Planning Commission

Wednesday, April 8, 2020 – 7:00 p.m.

RE: **CALIBER COLLISION AT 566 N. WALL AVE.
Site Plan Review**

The Site is located at approximately 566 North Wall Avenue in between Wall Avenue and North Harrisville Road (Hwy 89). The Developer is proposing to combine 5 parcels into a 2-lot commercial subdivision. They have also submitted a site plans to develop Lot 1 of the subdivision. We have completed a review of the site plan and have the following comments:

SHEET NO.
C-601

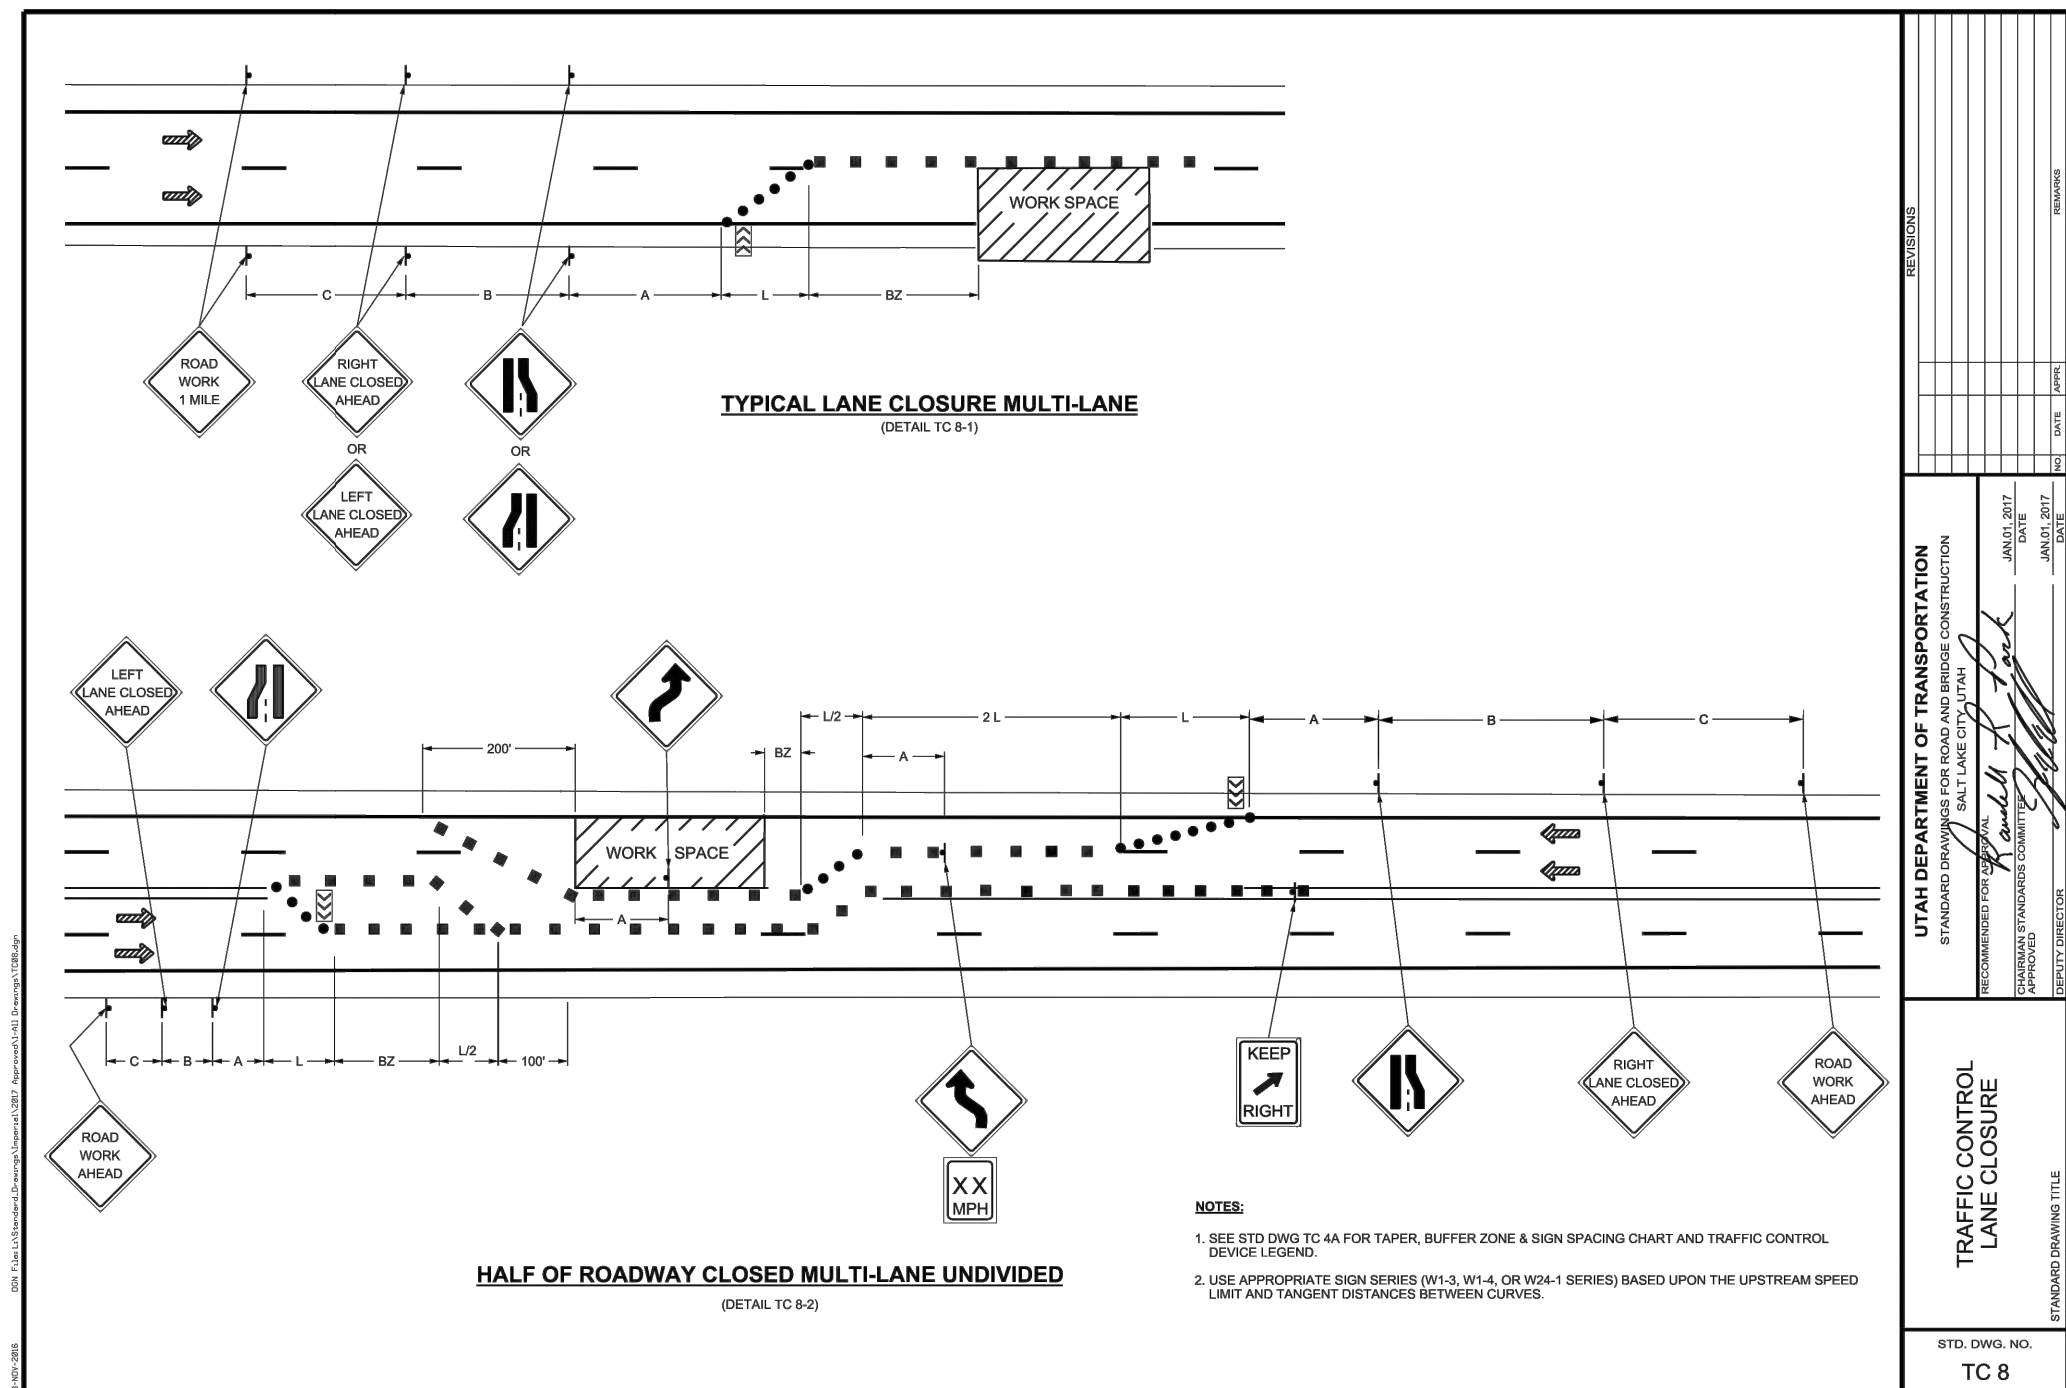
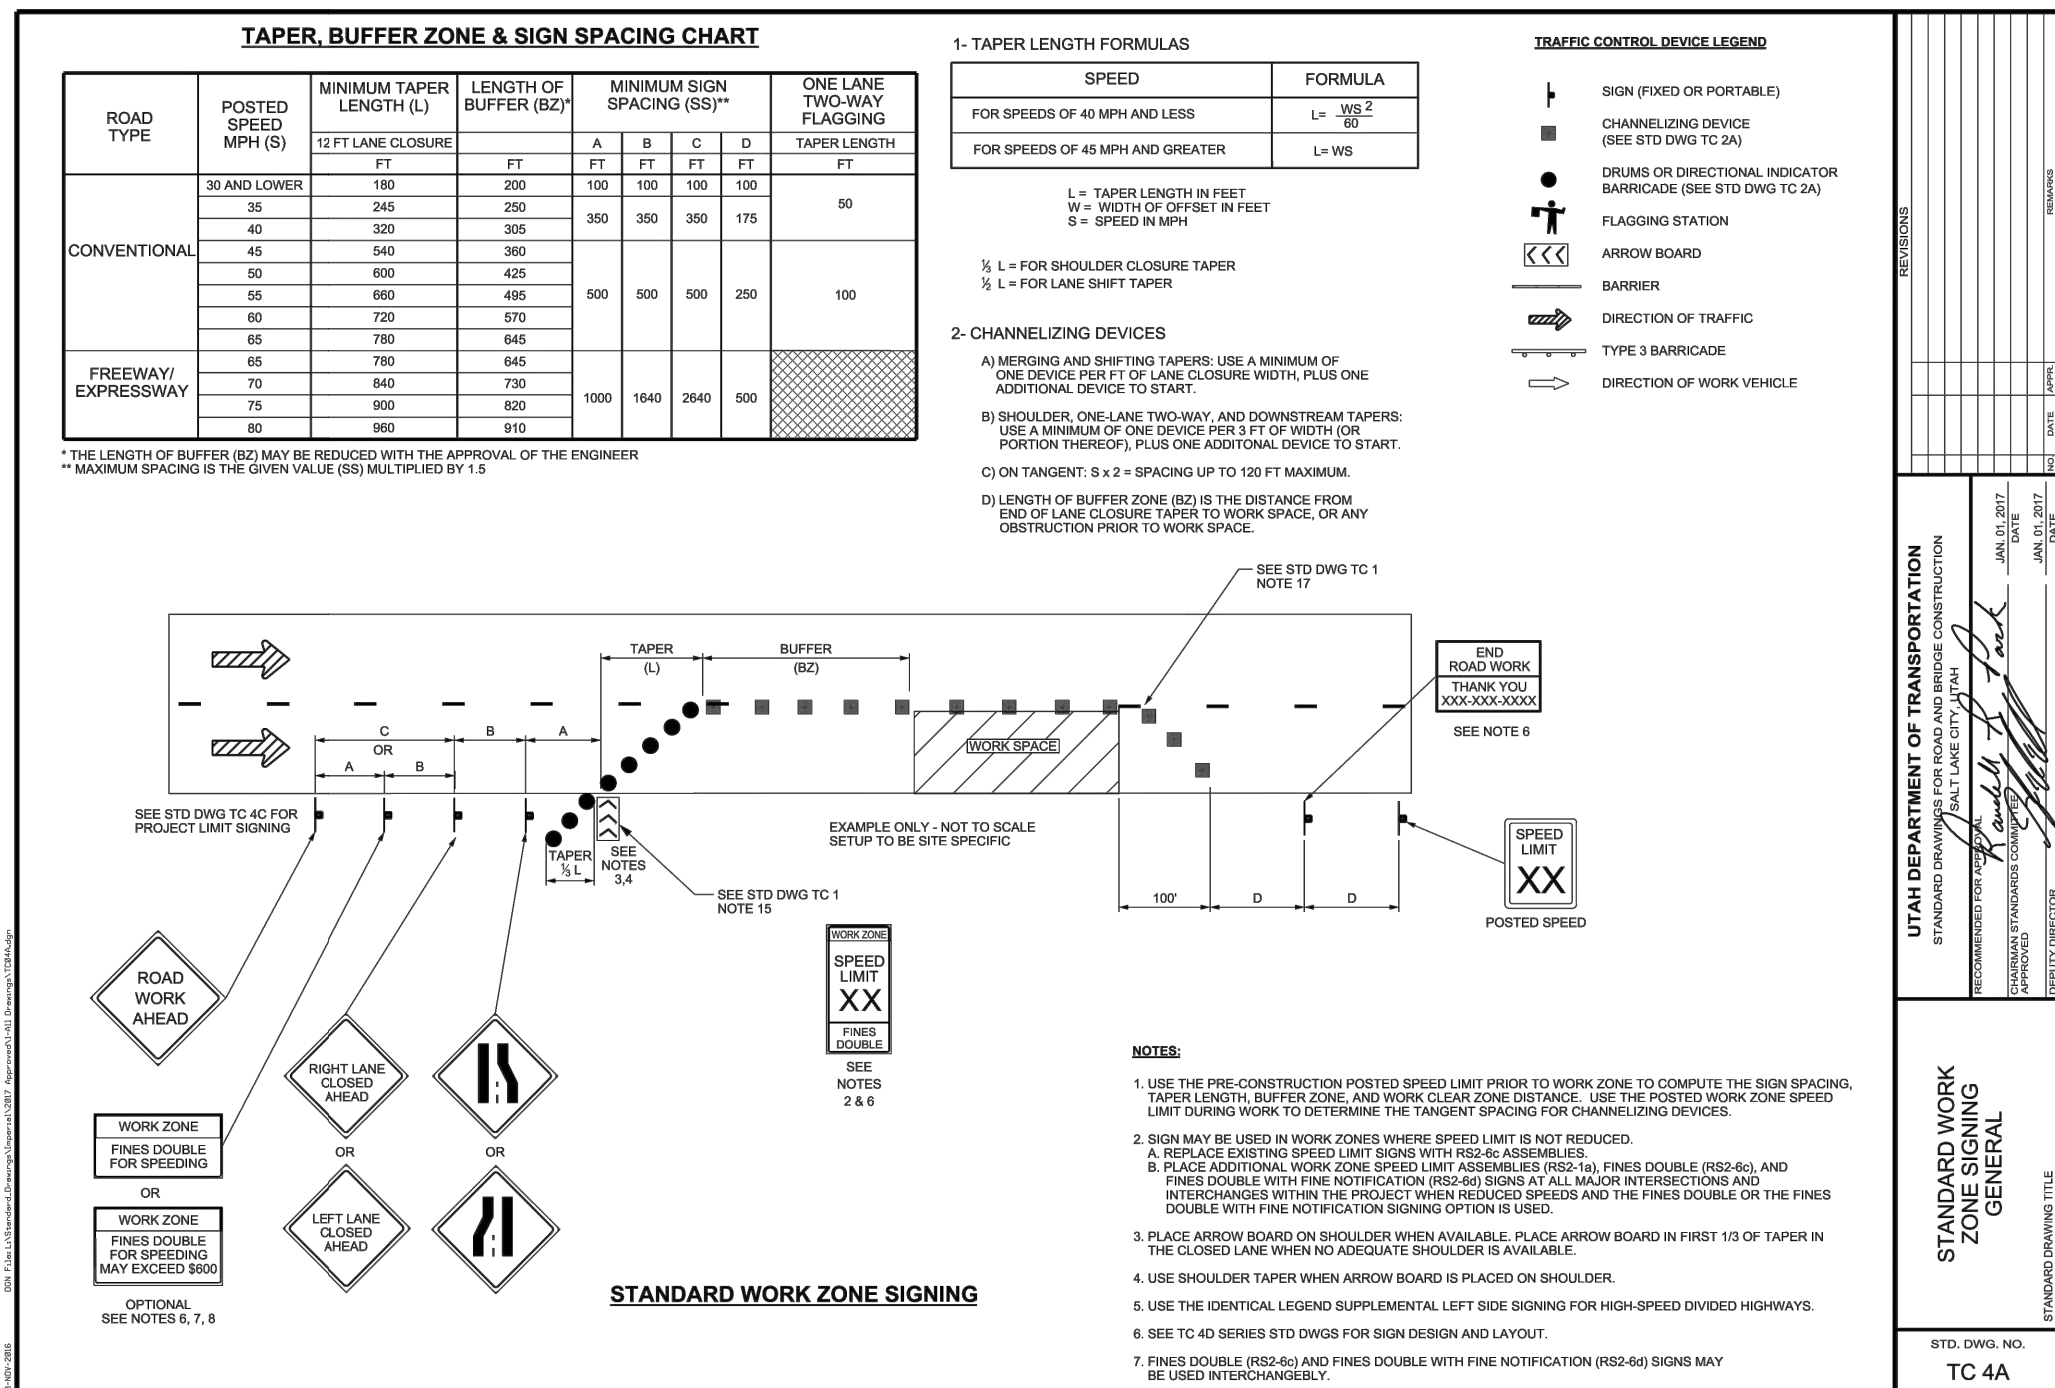
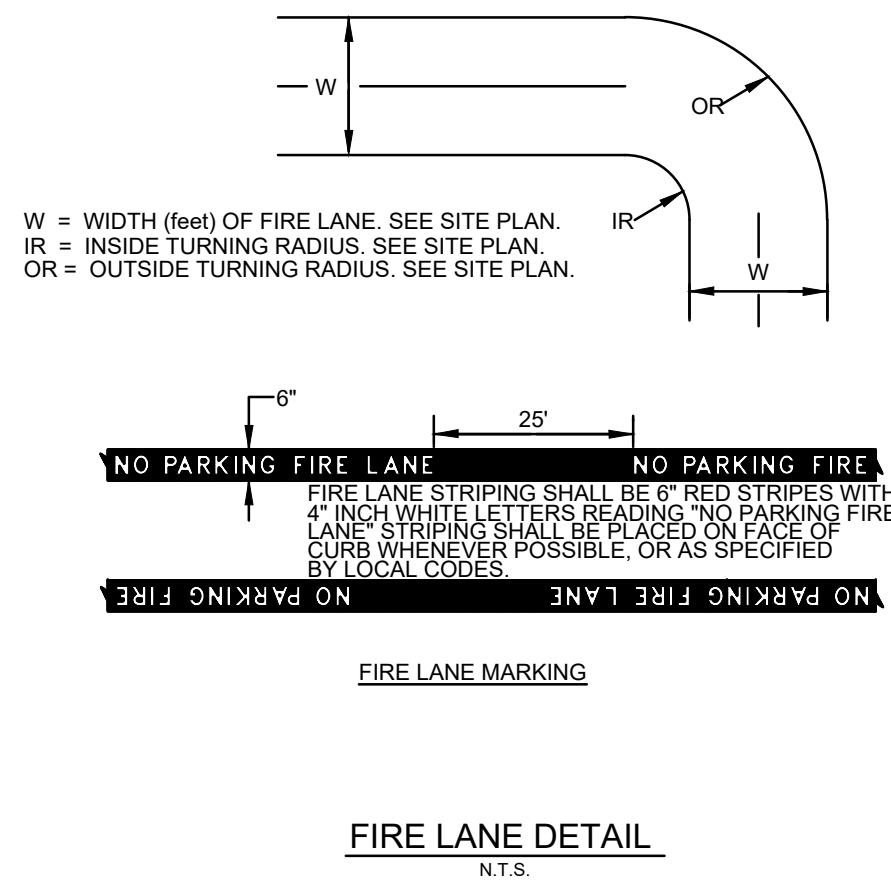
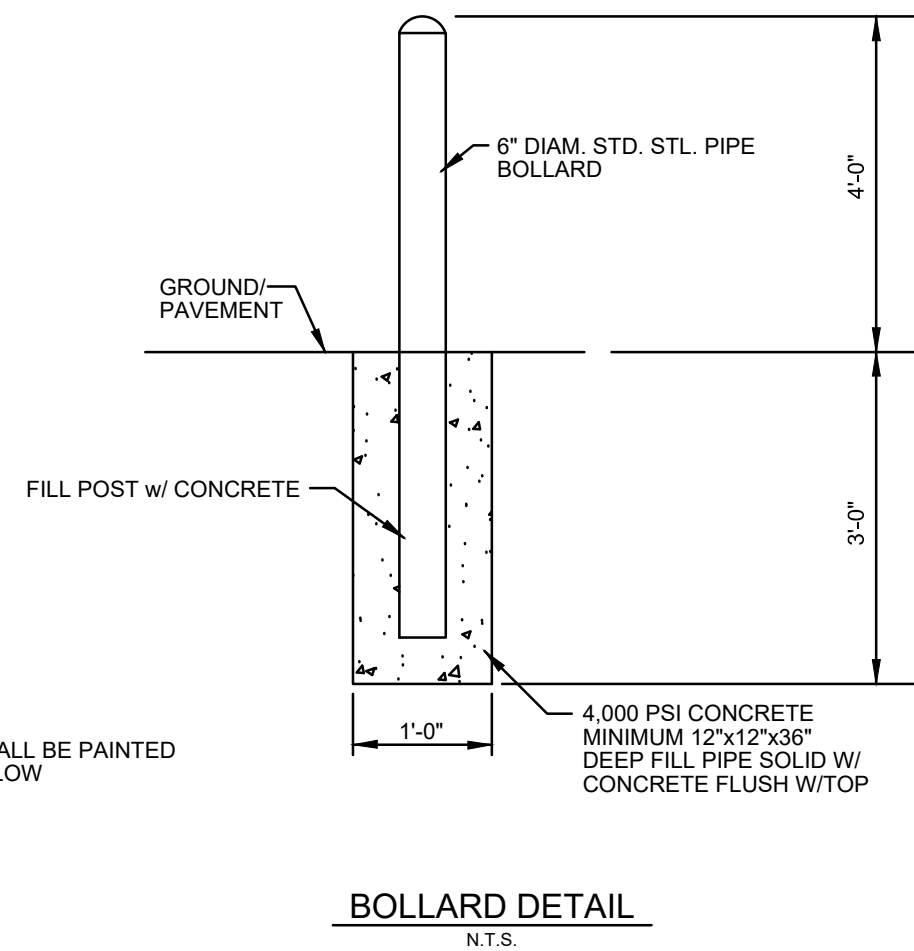
8. Revise parking stall configuration as needed. The stalls next to the detention basin aren't accessible due to the adjacent stalls.
9. A manhole is required at any bends on the storm drain or sanitary sewer pipe alignments.

10. Tie-in the 12" line from the detention area to a manhole.
11. Include a detail for the detention basin outlet structure in the plans. This structure should show the orifice size and configuration and have an overflow at the high water mark.

13. Include rim elevation for sanitary sewer manholes.
14. Update the landscaping plan to avoid placing large trees or shrubs over storm drain pipes and structures.
